Why Does My New Pump Look Different? - Water Pump 58-227, 228, 334

Application: Ford, Mercury 4 Cyl., 1981 - 1986. See catalog for specific applications.

COUNTERBORE DESIGN

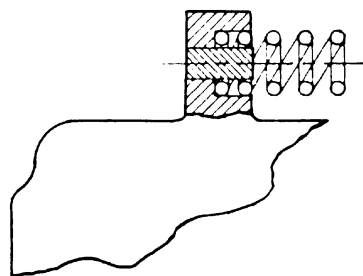
Caution: Ford has consolidated three pumps into one. Two are aluminum and one is cast iron. Any of these will fit the 1.6 liter engine. All three have slightly different designs to retain the tension spring, this spring will work with any of the designs shown below.

All three of these can be interchanged. However because of impeller clearance problems a thicker gasket is required. Failure to use the thicker gasket may result in engine damage. Two regular thickness gaskets may be used in place of the thicker one. If two gaskets are supplied with your pump, use them both.
